# UNITED STATES PATENT AND TRADEMARK OFFICE

APPLICATION NO.	FILING DATE	FIRST NAMED INVENTOR	ATTORNEY DOCKET NO.	CONFIRMATION NO.
10/537,008	05/25/2005	Sreeram Venkitasubrahmanian	US020475	1370
24737 7590 11/14/2007 PHILIPS INTELLECTUAL PROPERTY & STANDARDS P.O. BOX 3001 BRIARCLIFF MANOR, NY 10510			EXAMINER LE, TUNG X	
			ART UNIT 2821	PAPER NUMBER
			MAIL DATE 11/14/2007	DELIVERY MODE PAPER

<b>Office Action Summary</b>	<b>Application No.</b> 10/537,008	<b>Applicant(s)</b> VENKITASUBRAHMANIAN ET AL.	
	<b>Examiner</b> Tung X. Le	<b>Art Unit</b> 2821

**FIG. 6**

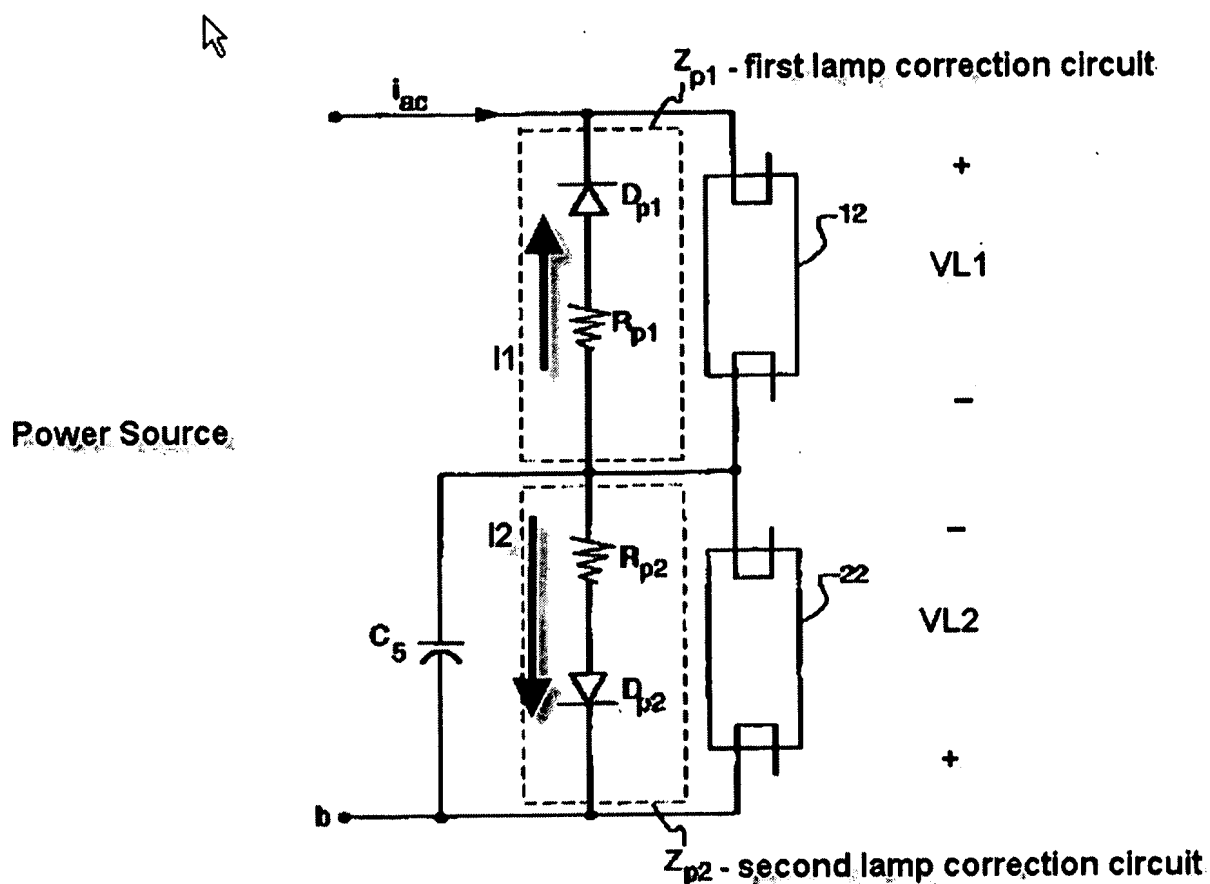
With respect to claim 5, Steigerwald discloses in figure 6 that the striation correction circuit comprises a first lamp correction circuit (Zp1) for generating the first striation correction current in the first fluorescent lamp (12) and a second lamp

correction circuit ( $Z_{p2}$ ) for generating the second striation correction current in the second fluorescent lamp (22).

With respect to claim 6, Steigerwald discloses that the first lamp correction circuit is arranged in parallel with the first lamp (figure 6) and the second lamp correction circuit is arranged in parallel with the second lamp (figure 6) and wherein the first and second lamp circuits are in series (figure 6).

With respect to claim 7, Steigerwald discloses that the first lamp correction circuit (Zp1) and the second lamp correction circuit (Zp2) each comprise a diode (Dp1 and Dp2) in series with a resistor (Rp1 and Rp2) and wherein the first and second lamp correction circuits are arranged symmetrically with the diodes opposing one another (figure 6).

With respect to claim 8, Steigerwald discloses in figure 6 that the first lamp correction circuit and the second lamp correction circuit comprises at least one transistor (having the two diodes [Dp1 and Dp2] functioning as semiconductor transistors).

With respect to claim 15, Steigerwald discloses in figure 6 that a striation circuit (Zp1 and Zp2) comprises a first lamp correction circuit (Zp1) for generating the first striation correction current (I1) in the first fluorescent lamp (12) and a second lamp correction circuit (Zp2) for generating the second striation correction current (I2) in the second fluorescent lamp (22).

With respect to claim 16, Steigerwald discloses that the first lamp correction circuit is arranged in parallel with the first lamp (figure 6) and the second lamp correction circuit is arranged in parallel with the second lamp (figure 6) and wherein the first and second lamp correction circuits are in series (figure 6).

With respect to claim 17, Steigerwald discloses in figure 6 that the first lamp correction circuit and the second lamp correction circuit each comprises a diode (Dp1 and Dp2) in series with a resistor (Rp1 and Rp2) and wherein the first and second lamp correction circuits are arranged symmetrically with the diodes opposing one another (figure 6 shows the diodes [Dp1 and Dp2] opposed direction to each other).

With respect to claim 18, Steigerwald discloses in figure 6 that the first lamp correction circuit and the second lamp correction circuit are comprised of at least one component selected from the group consisting of a diode (Dp1 and Dp2).
